Service Bulletin

No. : MZ07-036

Model: SR7001, SR8001

Subject: Correction of the Service Manual, PACKING (Accessories) parts list.

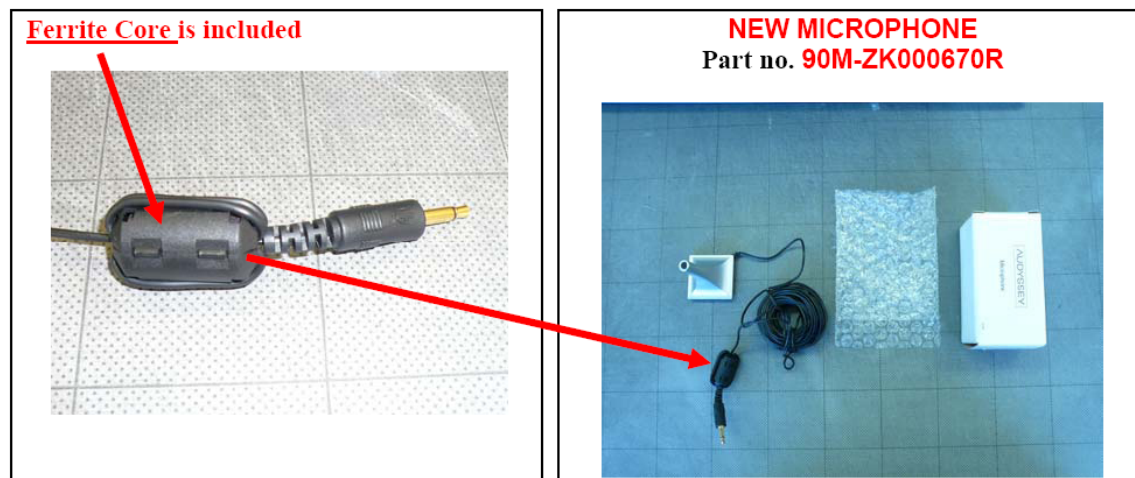
Symptom: The MICROPHONE part number mentioned on the SR7001/SR8001's Service Manual is incorrect. (Service Manual page 134 or 135)

Solution: Use the (MJI) part number listed in the Parts section when ordering a replacement Microphone.

OLD NEW	POS. NO.	VERS. COLOR	PART NO. (FOR EUR)	PART NO. (MZ)	PART NAME	DESCRIPTION
OLD	-		00M05CW009010	00M05CW009010	MICROPHONE	MIC AUDYSSET Ferrite Core is not included Factory code no. CMICROSR8001
NEW	-		90M-ZK000670R	90M-ZK000670R	MICROPHONE	MIC AUDYSSET Ferrite Core is included Factory code no. CMICROSR8001A
